DEESIDE WASTE TO ENERGY ANAEROBIC DIGESTION PLANT

DESIGN & ACCESS STATEMENT

1175-21-DAY-XX-XX-RP-A-0001-P03 - Design & Access Statement Deeside W2E AD Plant

This Design & Access Statement has been produced to document and record DAY Architectural's updates to the original design of the Deeside Waste to Energy Anaerobic Digestion Plant, Weighbridge Road. This Design & Access Statement supports the Section 73 application as submitted by the Deeside SPV, alongside any and all other documents which accompanies this application submitted to Flintshire County Council.

1175-21-DAY-XX-00-DR-A-20-0002 PROPOSED SITE PLAN

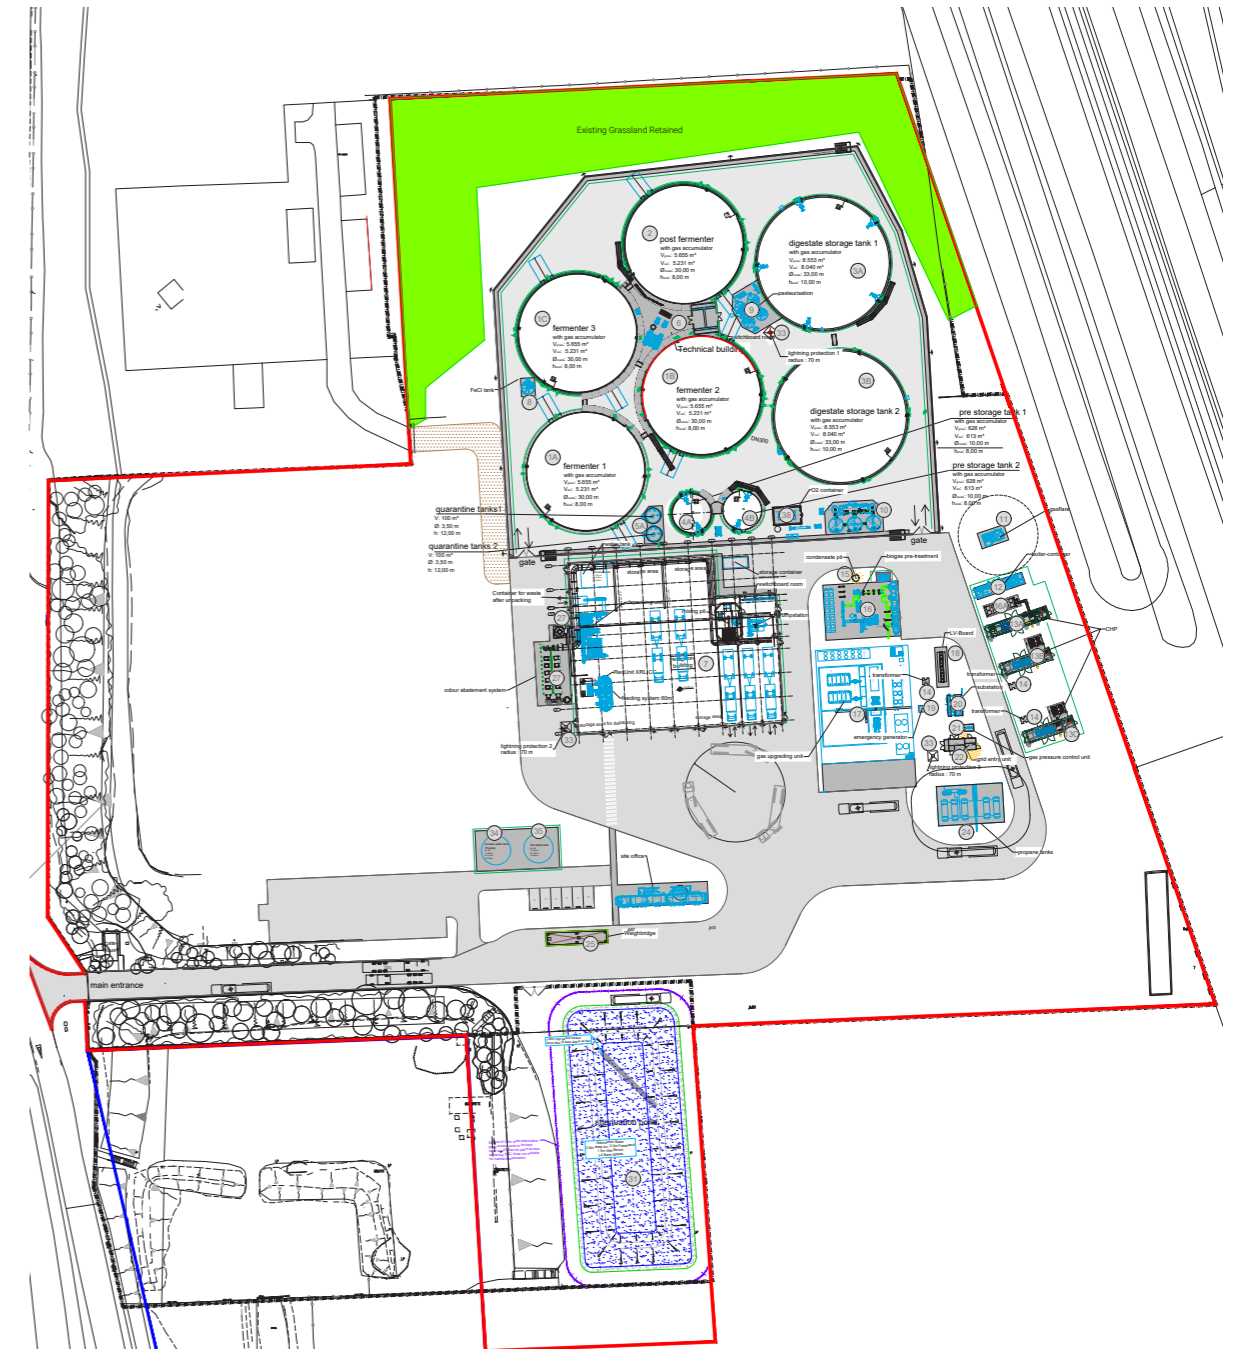
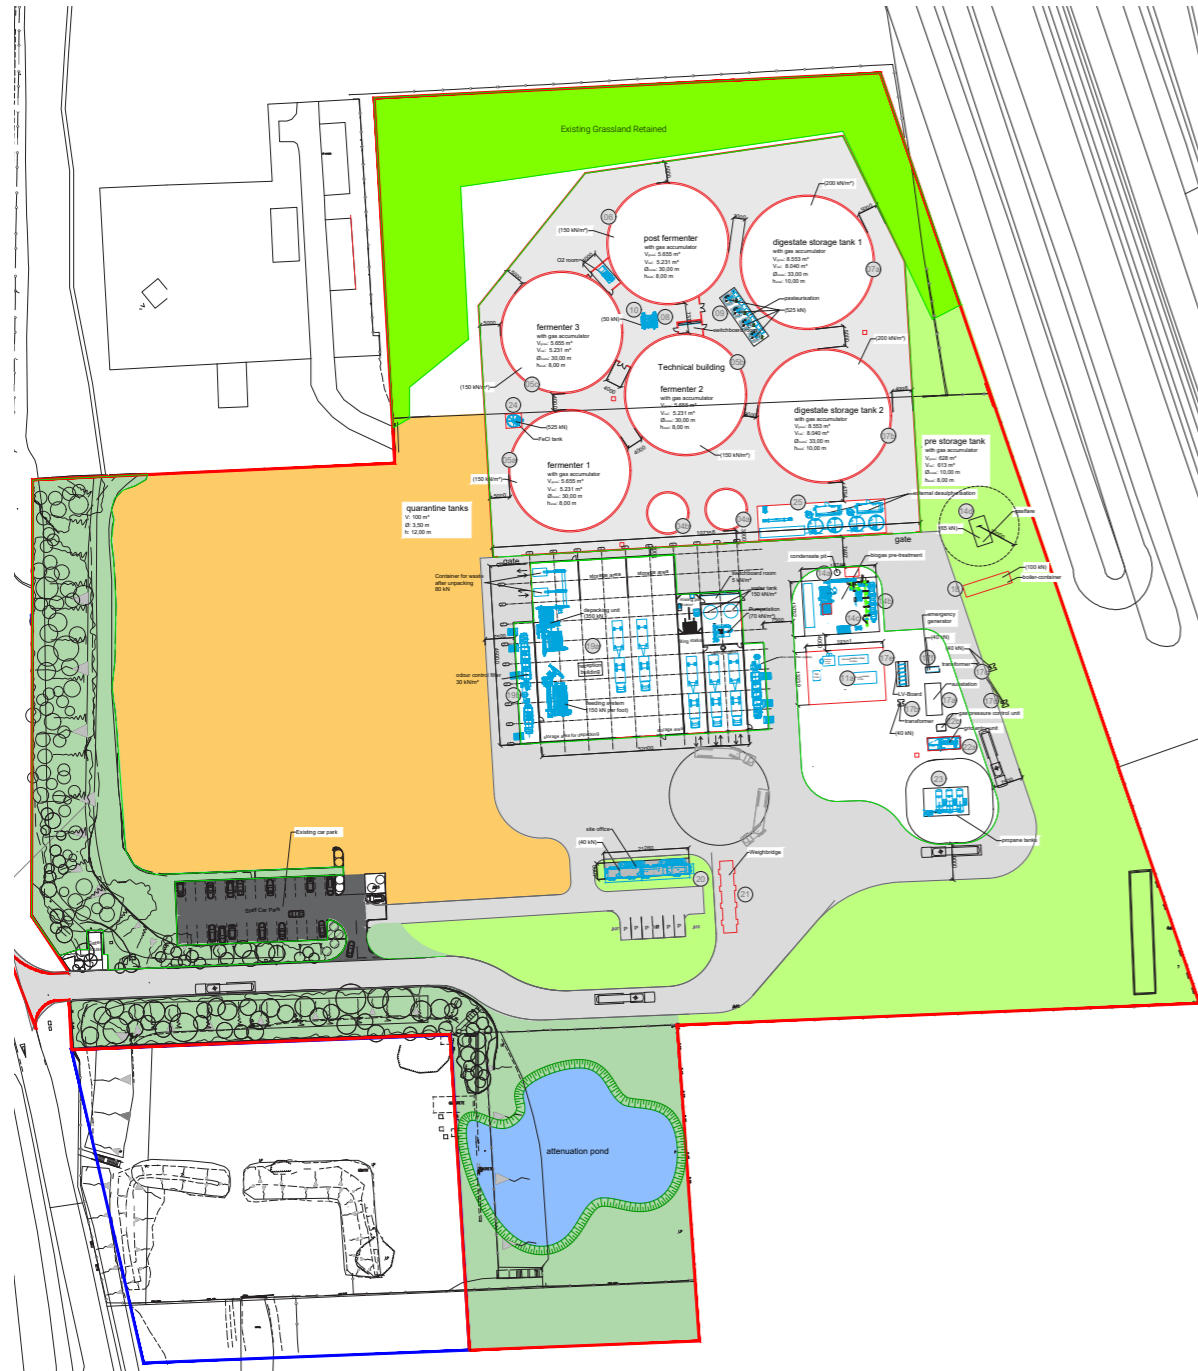
Reception building maximum height: 13.16m	<i>Reduction by 6.84m</i>
Reception building footprint: 2078m ²	<i>Reduction by 3328m²</i>
Bunded zone: 9469m ²	<i>Increase by 5132m²</i>
Application site area: 5.57ha	<i>No change</i>

- Site access / circulation road redesign, avoiding Easement on Eastern boundary
- Reduction in reception building footprint
- Reduced reception building height
- Increase to bunded tank area
- Optimised circulation / hardstanding
- Additional attenuation pond
- Increase to external plant area
- Relocation of CHP

1175-21-DAY-XX-00-DR-A-20-0002 PROPOSED SITE PLAN

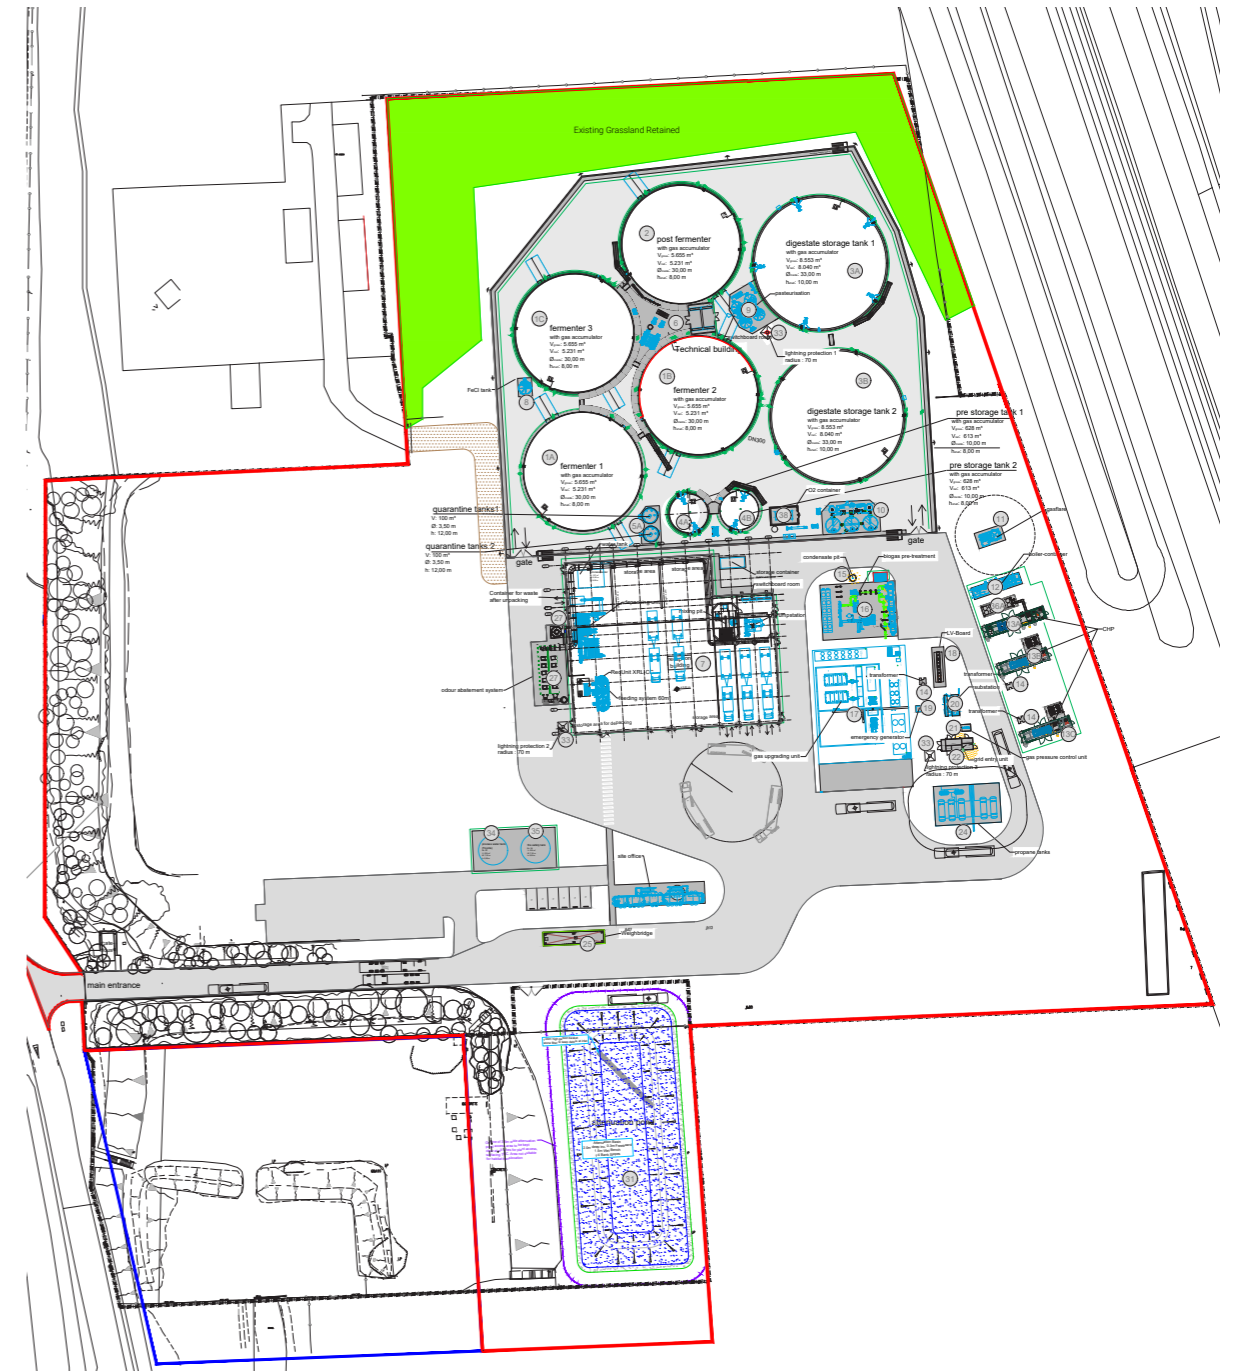
Reception building maximum height: 13.16m	<i>No change</i>
Reception building footprint: 2078m ²	<i>Reduction by 119m²</i>
Bunded zone: 9469m ²	<i>Reduction by 289m²</i>
Application site area: 5.57ha	<i>No change</i>

- Reduction in circulation
- Reduction in reception building footprint
- Increase to bunded tank area
- Optimised circulation / hardstanding
- Amended attenuation pond
- Increase to external plant area

1175-21-DAY-XX-XX-DR-A-20-0005 PROPOSED GA SITE ELEVATIONS

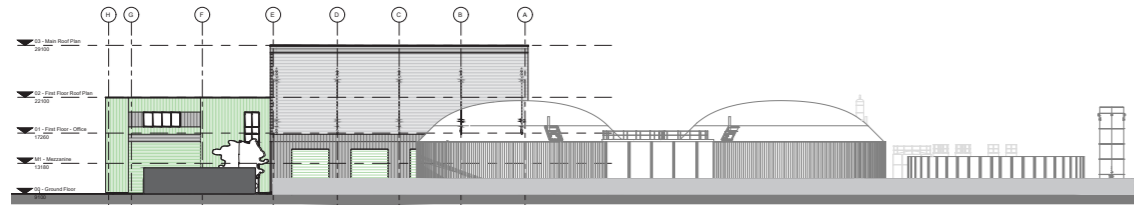
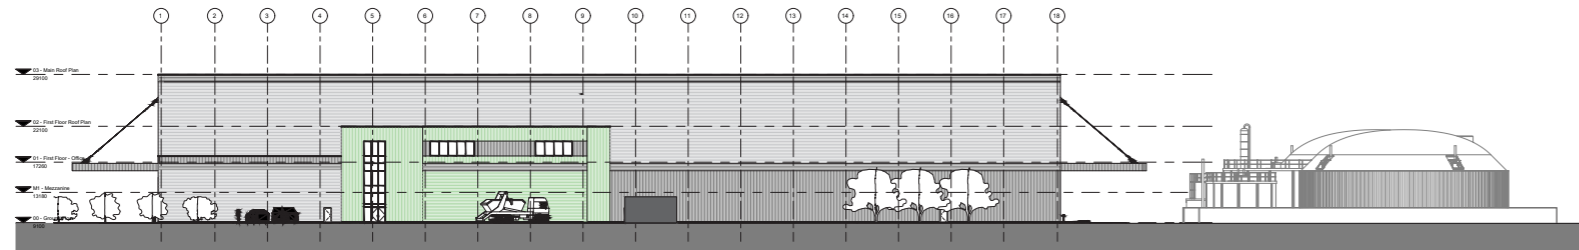
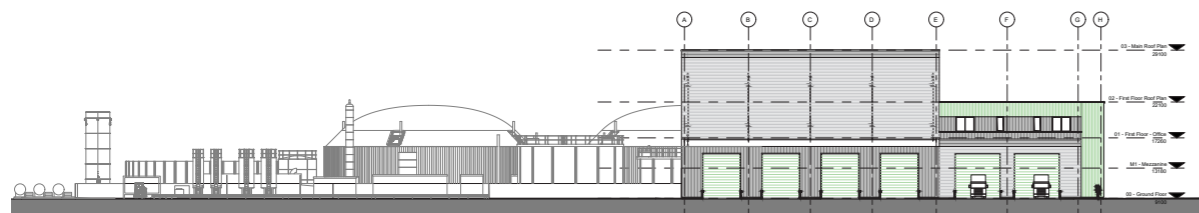
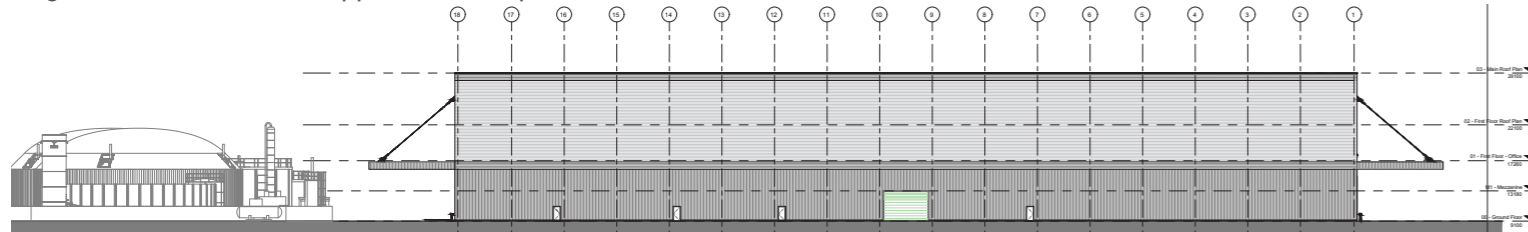
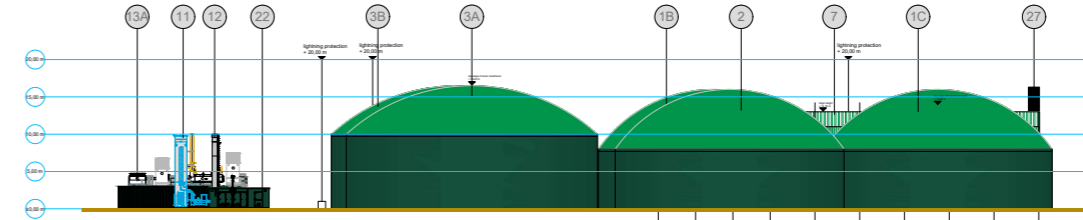
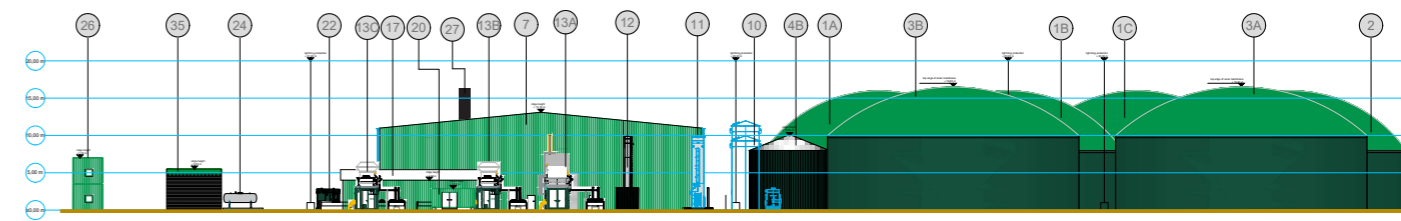
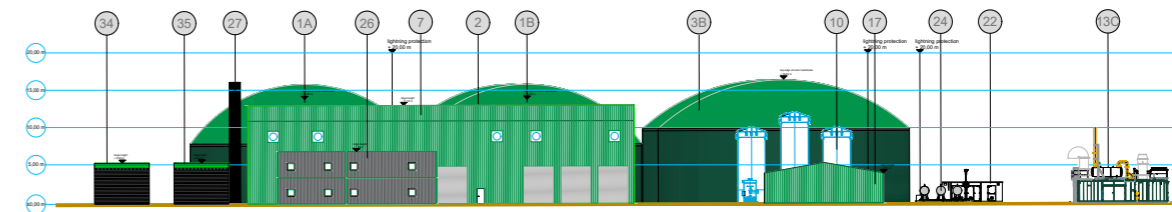
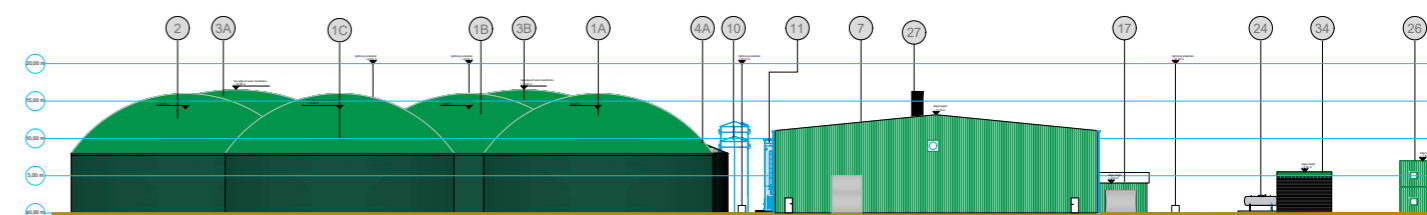
Reception building maximum height: 13.16m

Reduction by 6.84m

Reception building footprint: 2078m²

Reduction by 3328m²

Largest tank height: 16.6m

Increase by 3.6m

- Reduction in reception building footprint
- Reduced reception building height
- Increase to banded tank area and tank height
- Increase to external plant area
- Condensed site layout overall

1175-21-DAY-XX-ZZ-DR-A-20-0005 GA ELEVATIONS

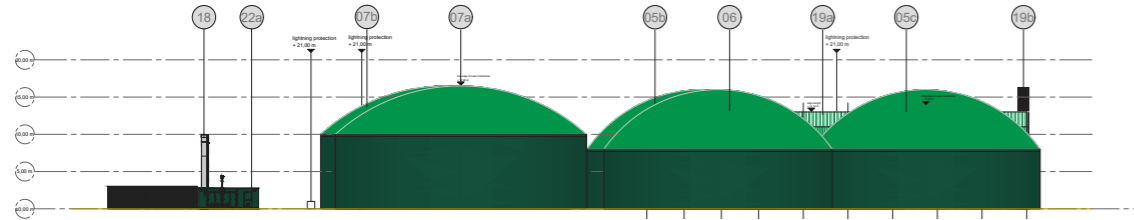
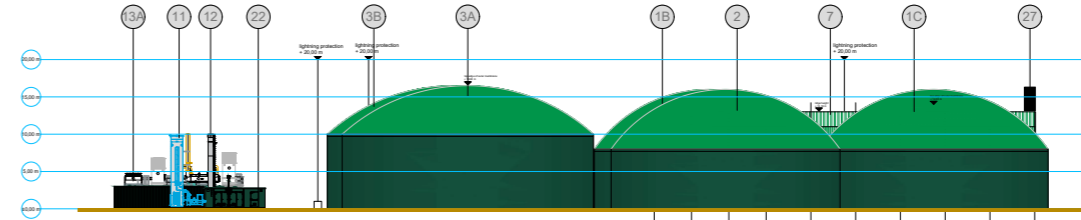
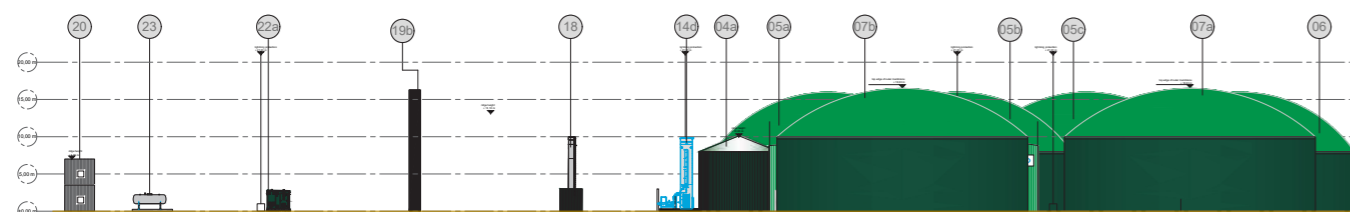
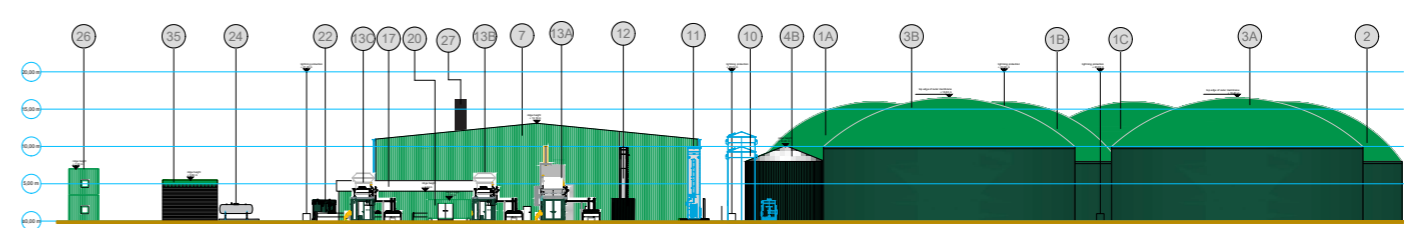
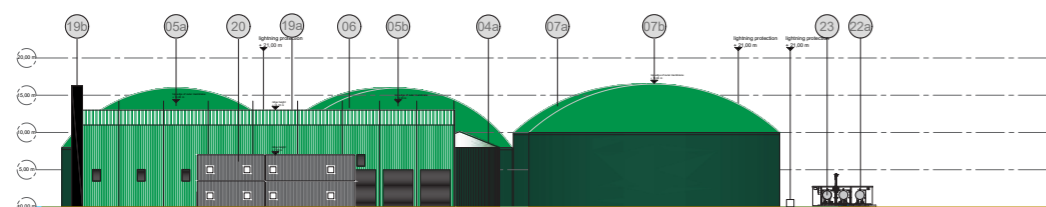
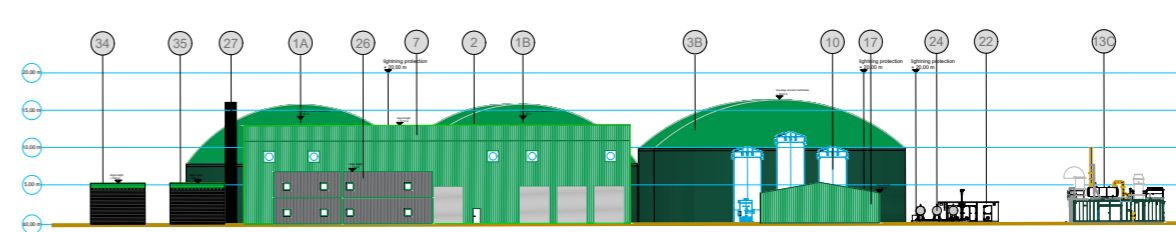
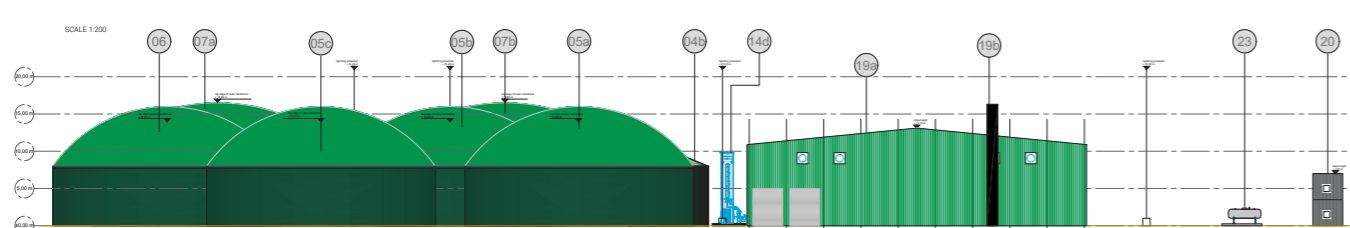
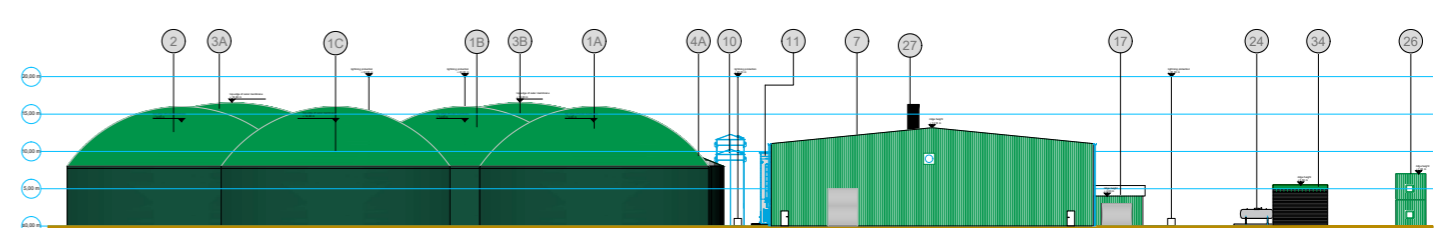
Reception building maximum height: 13.16m	<i>No change</i>
Reception building footprint: 2078m ²	<i>Reduction by 119m²</i>
Bunded zone: 9469m ²	<i>Reduction by 289m²</i>
Application site area: 5.57ha	<i>No change</i>

- Reduction in reception building footprint
- Increase to bunded tank area and tank height
- Increase to external plant area
- Condensed site layout overall
